## Houston Import Project

Calpine's Views in the Context of the Energy-Only Market

ERCOT Board of Directors Meeting August 17<sup>th</sup>, 2010

North\_Houston CSC

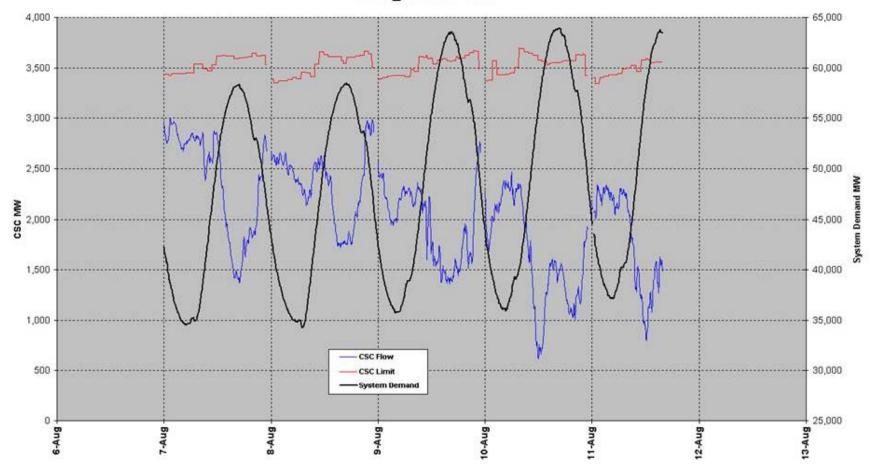
The North-Houston CSC rating has been more than adequate capacity during this summer's peak and a snapshot of recent data shows that the current week's load flows amount to less than half of the CSC's limit; these flows should be even further mitigated by the TNP One-East Bell County project that has an in-service date later in the year.
